- A. Radio Noise Interference Suppression Spark Plug
- B. Remote Control Attaching Kit - 1972 Merc 200 Model
- C. Distributor Cap Clamp Installation
- D. Wiring Diagram - 1972 Merc 800 Operator's Manual
- E. Throttle Flex Shaft Rubbing - 1972 Merc 110-75 Models
- F. Ignition Coil Return - Part No. A-336-4409A1

D. WIRING DIAGRAM - 1972 Merc 800 Operator's Manual

E. THROTTLE FLEX SHAFT RUBBING - 1972 Merc 110-75 Models

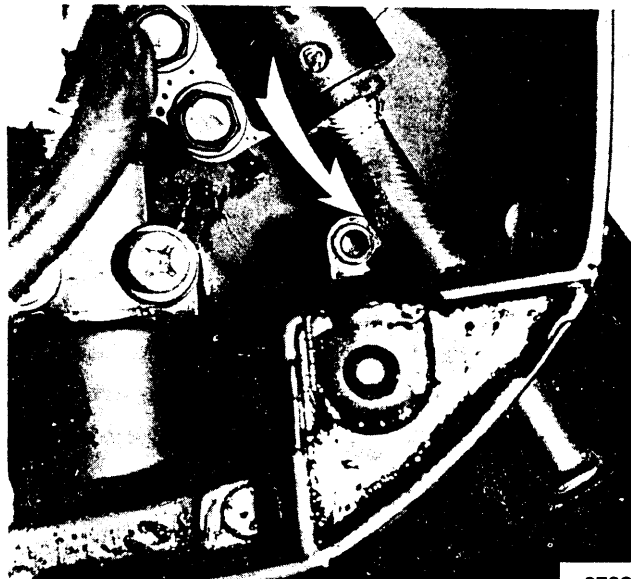
Model **1972** Merc 800 engines (Serial No. **3307347** and up) will not be wired as shown in the Owners Operation and Maintenance Manual (wiring diagram on Page **15**, Figure 17). The wiring diagram for Merc 800 engines (Serial No. **3307347** and up) is shown in the new Outboard Service Manual, Section 3, Part G, Page 3G-8.

Figure 1.

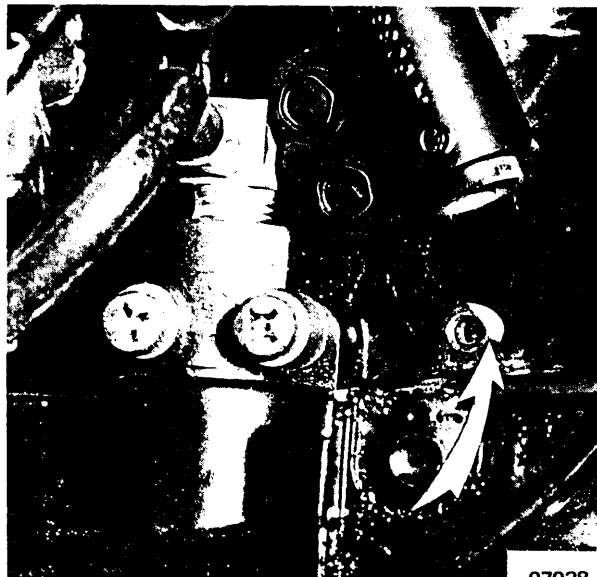
Model 1972 Merc 110 engines (Serial No. 3269072 and below) and 1972 Merc 75 engines (Serial No. 3282747 and below) require that the bottom cowl be reworked to prevent chaffing of the throttle flex shaft. A portion of the screw boss on the bottom cowl must be filed or ground-off as shown in Figures 1 and 2.

Flat rate for this modification will be 0.3hrs.
